MANDATORY SERVICE BULLETIN NO. MSB 40-093 REV. 0

Type: DA 40

Replacement of baggage nets with defective buckles.

Figure 1 - Baggage net installation.

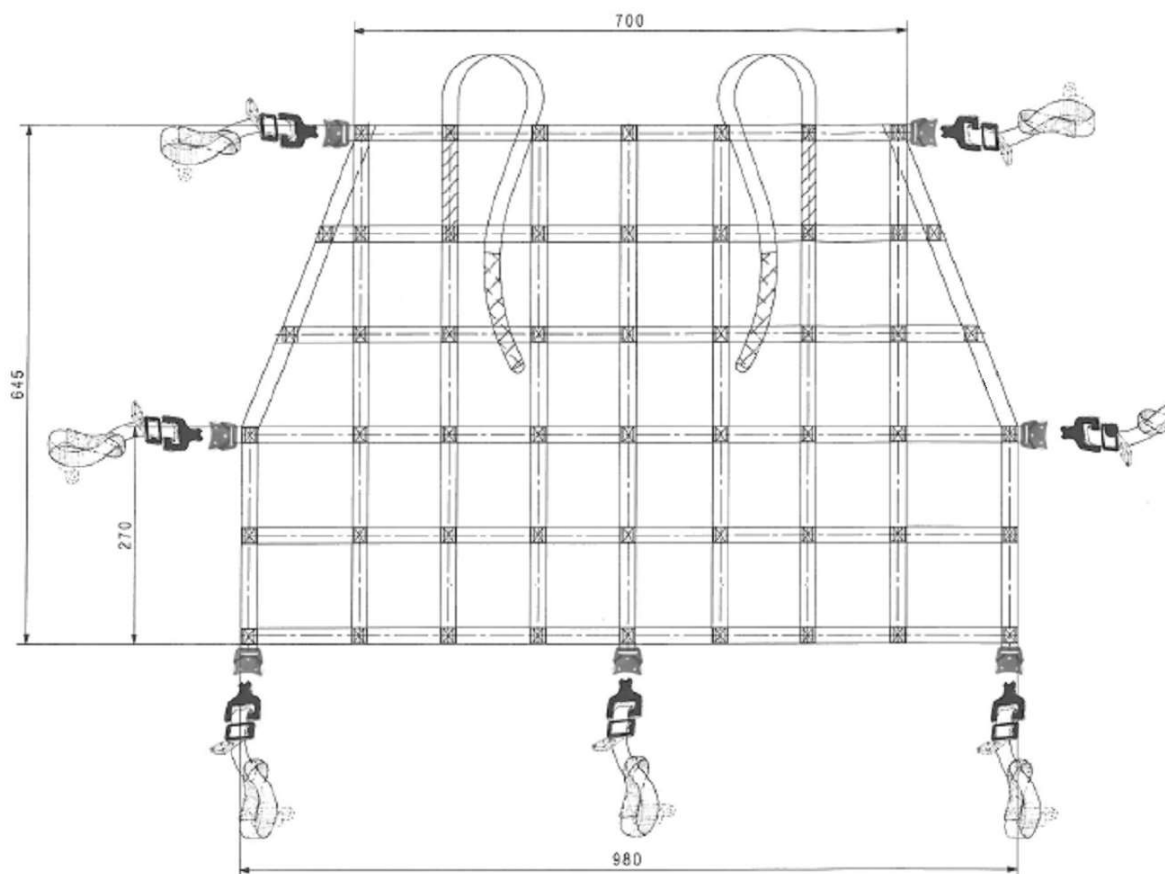
It has come to Diamond's attention that baggage nets with defective buckles have been installed on several aircraft due to a quality escape. These defective buckles may not maintain sufficient holding force and could pose a hazard to the passengers and crew. Effective immediately, these cargo nets are not to be used. Diamond will provide replacement nets to all those affected.

1. Refer to Section I.2. Identify if the baggage net in the aircraft is an affected net. Use the part number and date of manufacture to identify the net.
2. If an affected net is installed, clearly mark the currently installed net as defective, and remove it from the aircraft.

3. Destroy the removed baggage net, or return it to Diamond Aircraft Industries.
4. Install the new baggage net provided by Diamond Aircraft Industries.
